North East Link

Eastern Freeway Upgrades UDLP Submission

Introduction

Figure 4. Existing and NELP proposed noise wall heights.

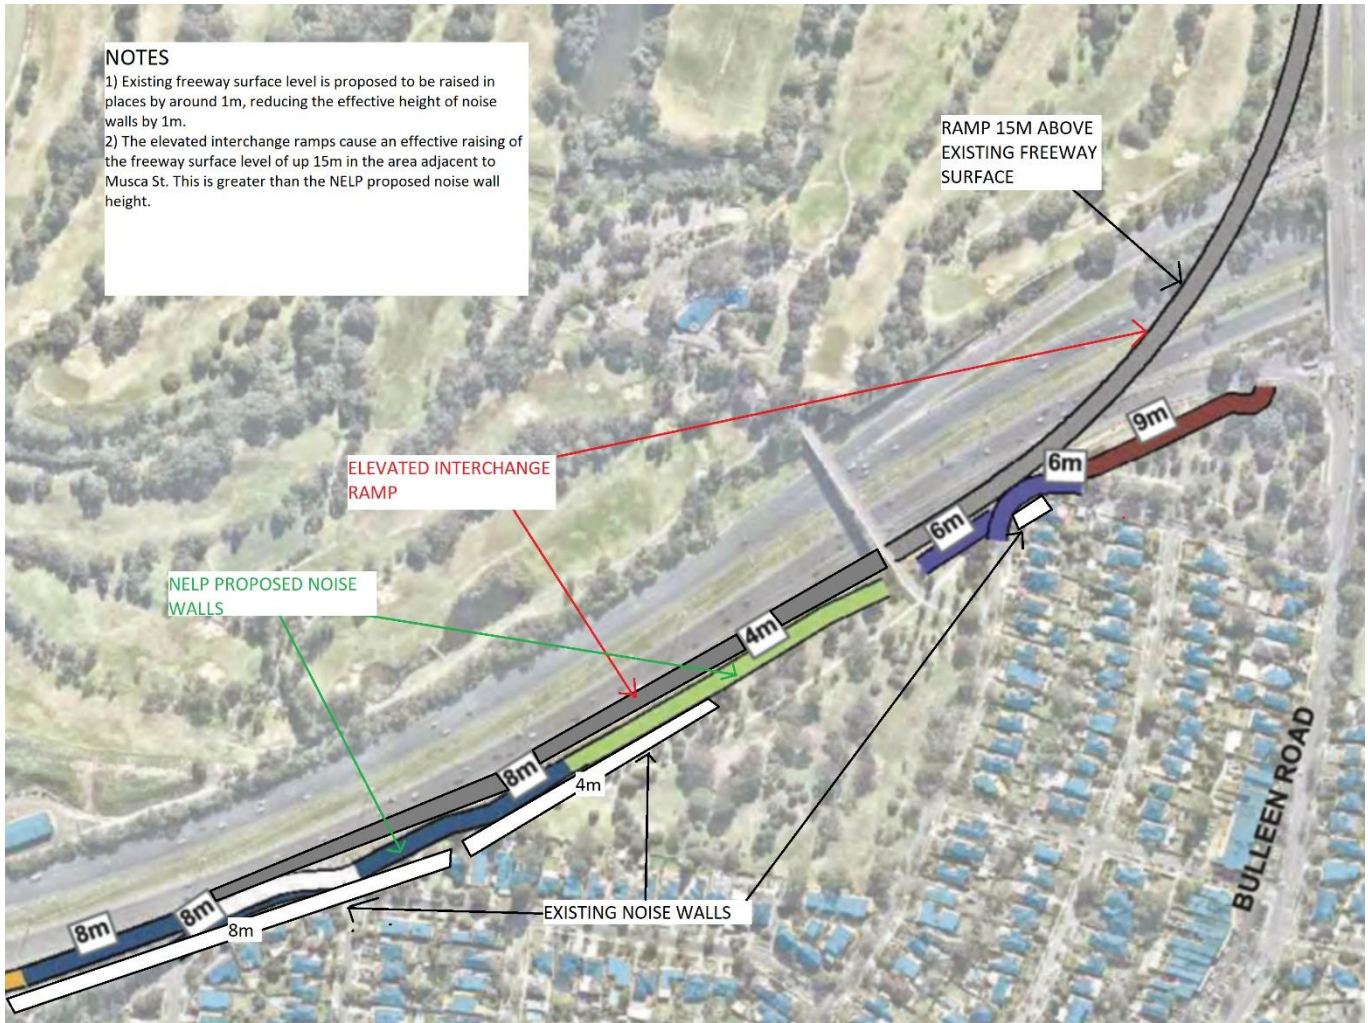
NELP also proposes to increase the surface level of the Eastern Freeway by around 1m in many places. This reduces the effective height of noise barriers by that same 1m amount. This is of particular concern around the Orion St area, where the existing and proposed noise walls are of the same 8m height. This would result in a reduction in noise protection for residents.

A reasonably practicable resolution to this is to construct all noise walls adjacent to the interchange at a minimum 10m height. Where overshadowing is of concern, opaque Perspex may be used.

As an alternative, a sound tube style arrangement may be used, similar to the one installed on the Bolte Bridge in Flemington.

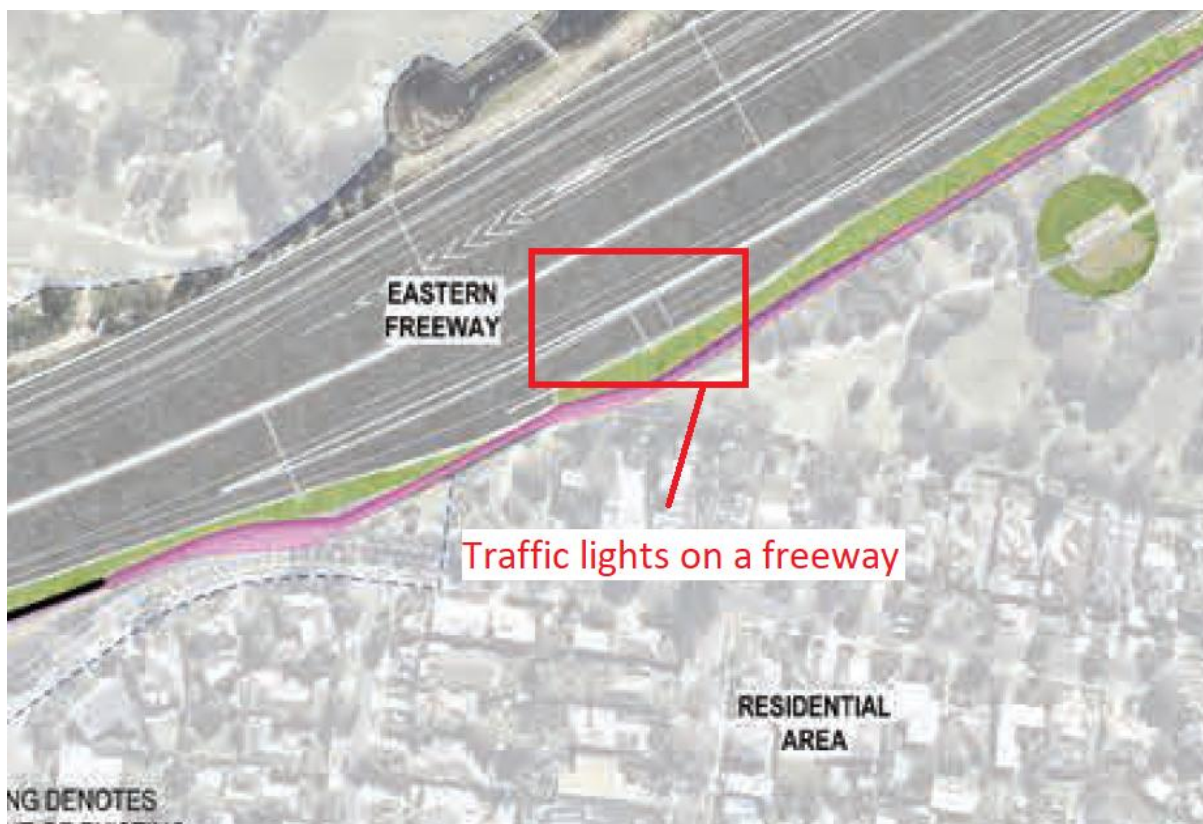
EPR code NV14¹ requires that “Opportunities to encourage heavy vehicle drivers to reduce use of engine brakes must be considered, where practicable.” As it is clearly practicable to remove the traffic lights on the NELP/Eastern Fwy citybound ramp and manage freeway traffic volumes at the local road onramps (as is already included in the NELP design), NV14 requires that this be done.

The clear scenario of having a long downhill ramp to a set of traffic lights is that trucks will conduct long, noisy engine braking. They will then accelerate away, noisily changing gears, with a plume of black smoke with each gear change. As the three lanes merge into one, the ‘dragstrip’ effect will occur, with cars accelerating to beat each other to the merge. Motorbikes in particular will be very noisy here.

NELP must provide clear evidence that this localised increase in noise and air pollution was taken into account as a part of the relevant published EES documentation.

Figure 1: Relative walking distances

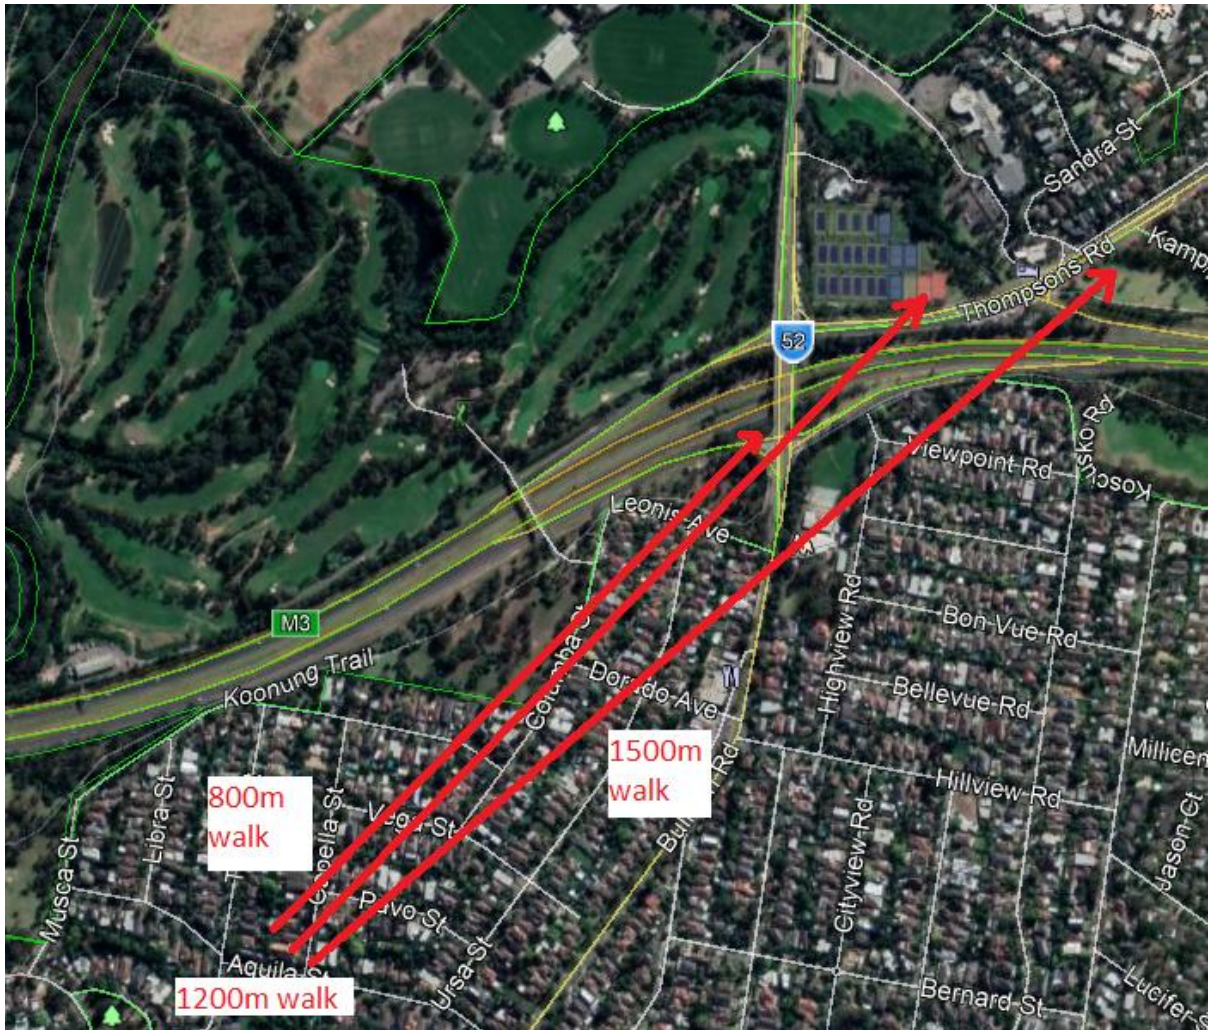
Many North Balwyn residents access the 905 SMART bus (supplemented by the 305 at peak times) at the Bulleen Road/ Eastern Freeway city bound on-ramp which is an 800m walk away in the example below.

In this area, the trip home from the city is either by the very slow and meandering 200 bus or a 1,200m walk from the stop on Thompsons rd. This is due to no corresponding outbound bus stop existing at the Bulleen Rd/Eastern Fwy offramp. At 800m this is already verging on being so distant as to be unworkable, yet despite this it is a well-used bus stop (presumably due to the lack of any workable alternative) with an average daily boarding of 213 passengers which is more than double the ridership of the existing Kiss and Ride bus stop (adjacent to the proposed Bulleen Park and Ride), despite the Kiss and Ride stop catering for more bus routes than the Bulleen Rd/Eastern Fwy onramp bus stop⁴.

The proposed location of the Bulleen Park and ride makes this even worse, with both trips at around the 1500m mark. This is clearly not a feasible transport option, particularly for the young or elderly.

Figure 2. Burke Rd Bus Stop on NEL Busway.

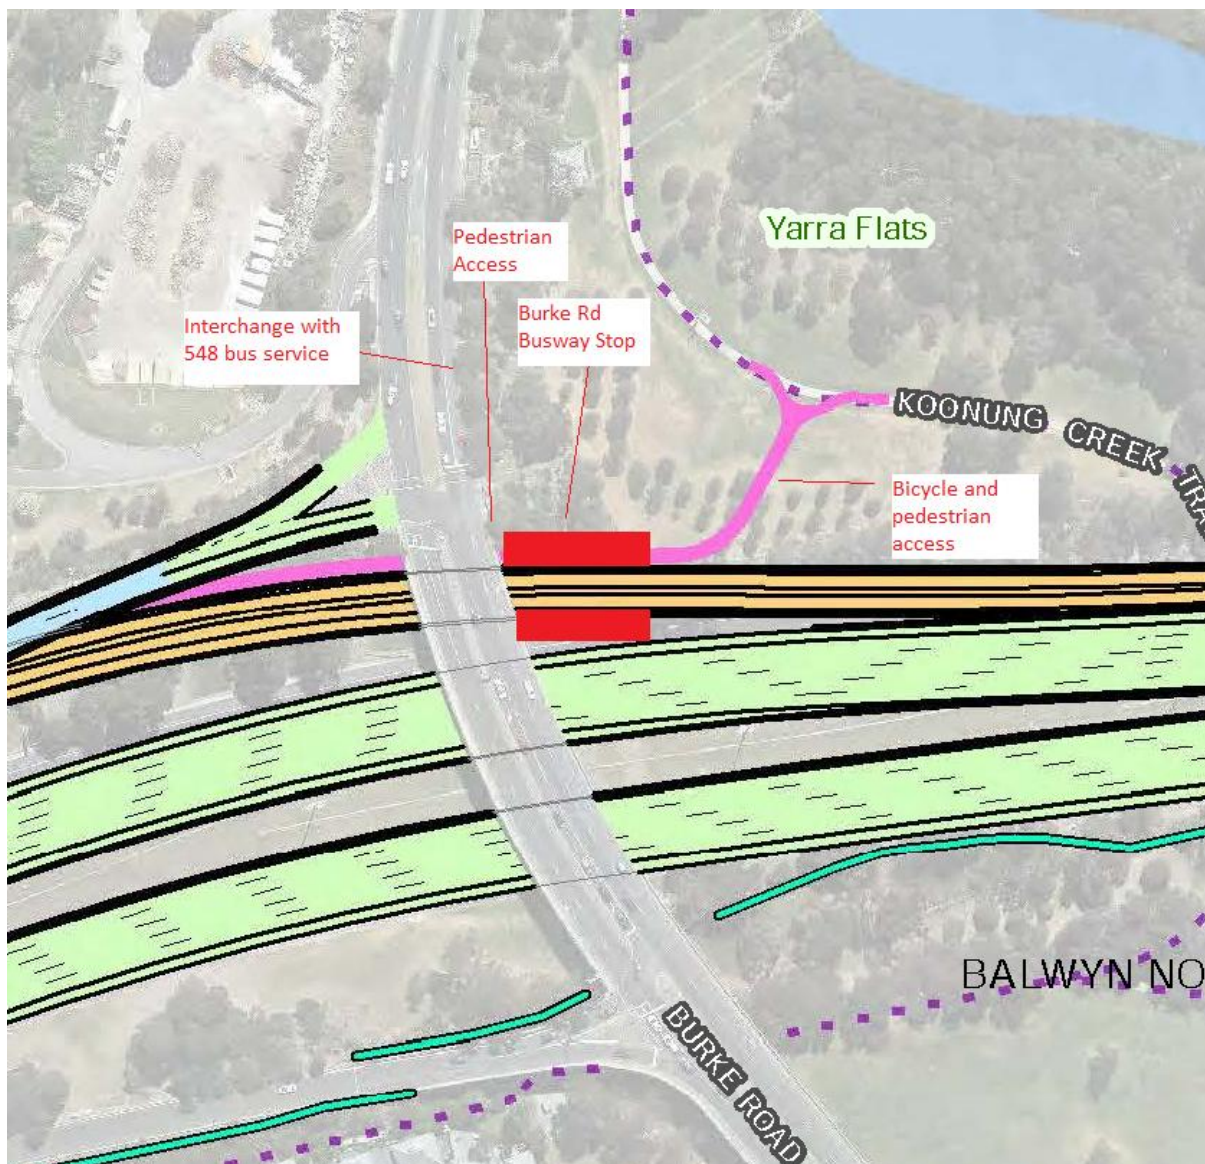
Assuming that the decision to move the park and ride to a location largely unfeasible for pedestrian access from North Balwyn has already been taken and that the suggested underpass is being rejected due to the size of the interchange that NEL wishes to impose on North Balwyn, an alternate bus stop must be provided.

The most sensible and practical location for this is at the Burke Rd overpass on the north side of the Eastern Fwy. There is room here for a regular bus stop along the busway. Good pedestrian and

cycling access already exists in this location. In addition to this, it would allow connection to the 548 bus service. This is crucial as there is no 'North East Link' for public transport in the project so far. This connection of the north-south 548 bus with the Busway would provide the sorely lacking connectivity and increase usage of both the busway and 548 bus.

Figure 6A. O'Brien Design

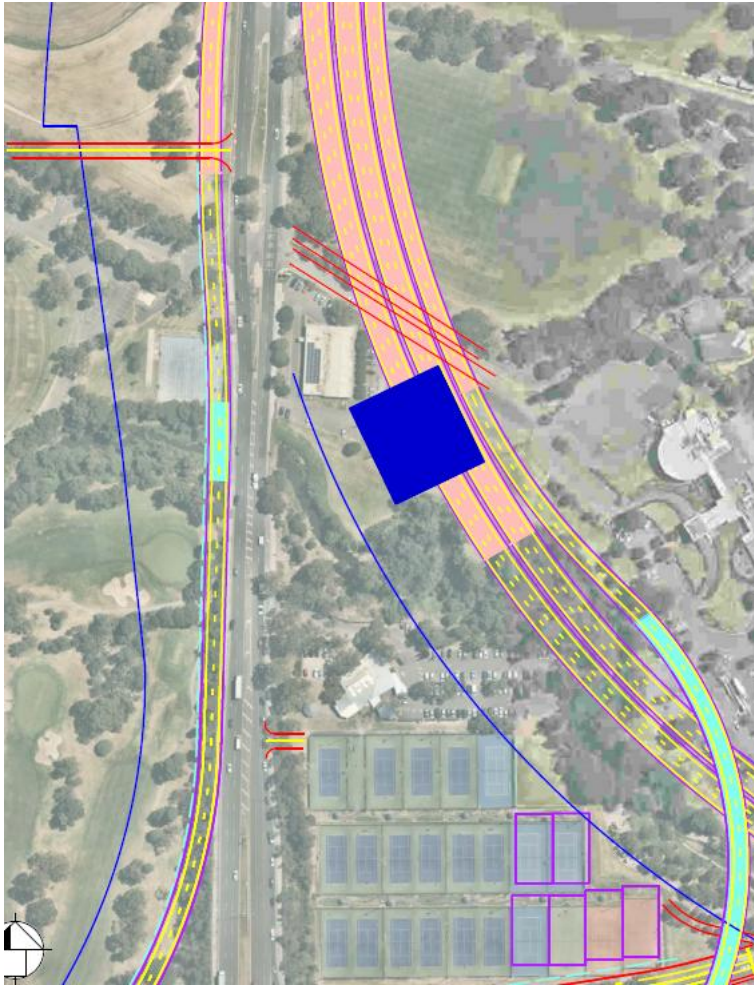
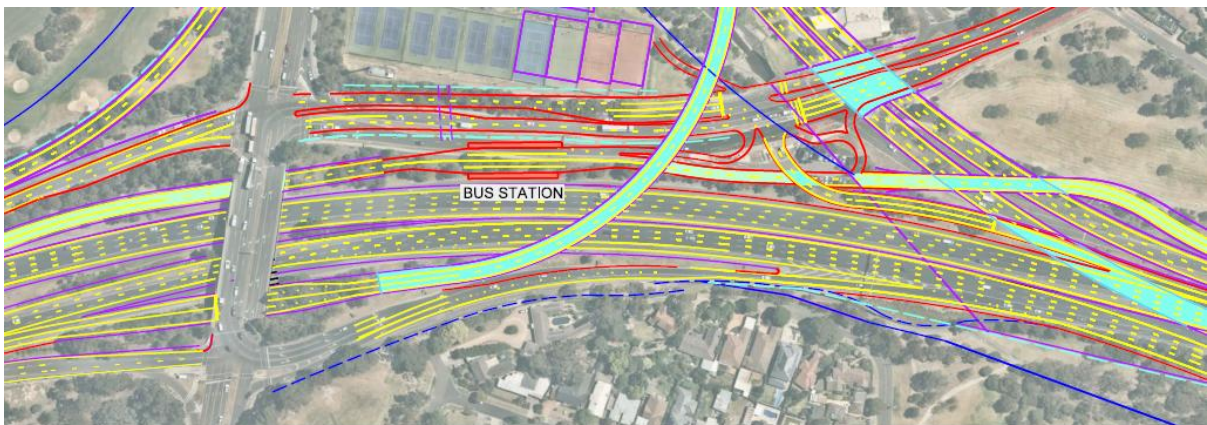
The NELP reference design shows all four ramps of the NELP southern interchange as being overhead. The alternate O’Brien design places three of these in a trench (no tunnel extension required), significantly reducing noise and visual impact of the interchange. The O’Brien design fits within the existing NELP defined project area.

It is reasonably practicable to insist that the O’Brien design be implemented as the design for NEL.
